POS FOOTPATH TREE SURVEY

RAF UPWOOD

Prepared For Vistry

ISSUE 1

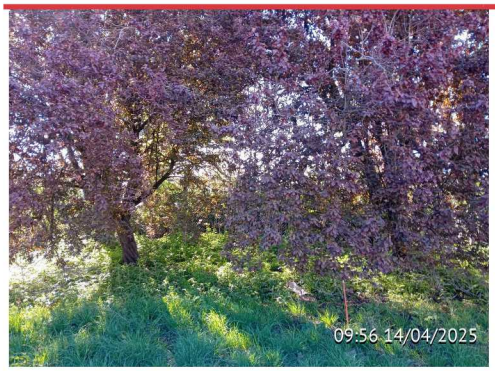
Pos footpath pinned out. Works have stopped March 28th as tree works had not been foreseen.

Assigned To T360- Cherry Prunus Sp.

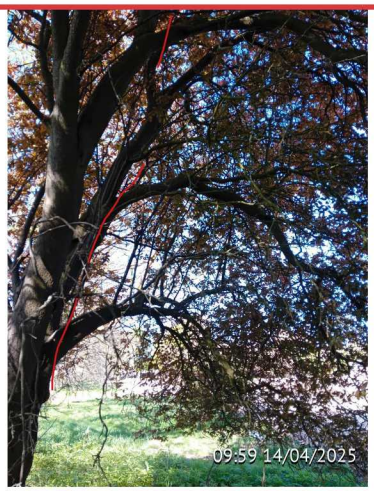
Picture showing tree overhanging pin preventing construction. Crown to be lifted to 3.5m to allow access for plant.

Assigned To T360- Cherry Prunus Sp.

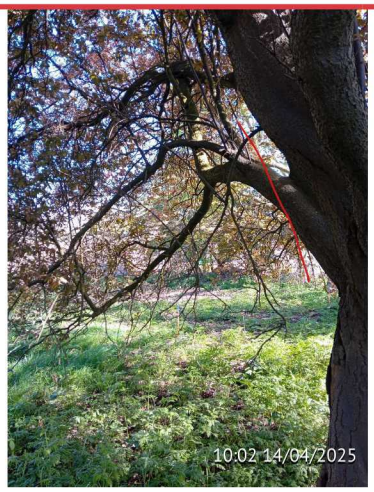
Suggested cuts to tree in order to raise crown. Crown to be lifted to approx 3.5m to allow for enough space for plant to cross underneath.

Assigned To T361- Cherry Prunus Sp.

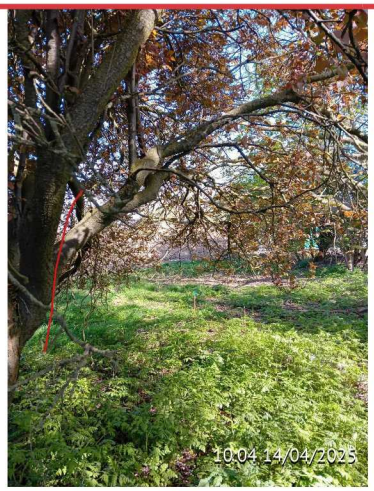
Recommended cut line to raise canopy. 1 limb to be cut which will raise canopy to 3m.

Assigned To T361- Cherry Prunus Sp.

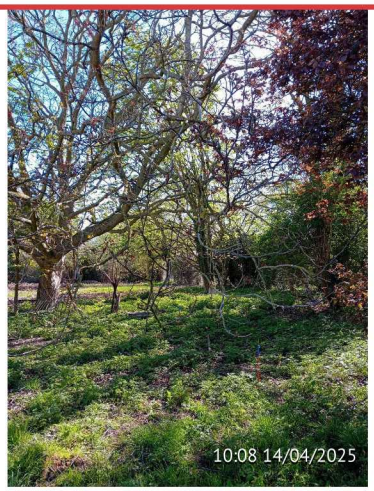
Recommended cut point to raise canopy level for access

Assigned To T362- Sycamore Acer Pseudoplatanus

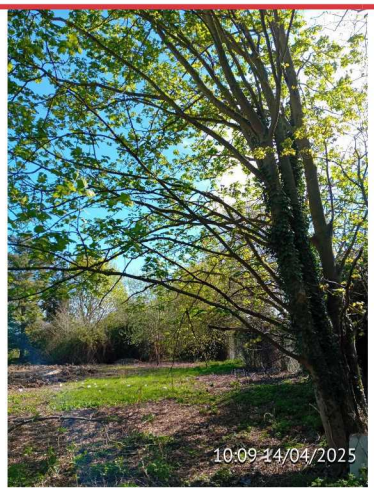
2 low hanging limbs to be removed, tree at first appears dead but signs of budding. Crown to be raised above 3.5m to allow for plant access.
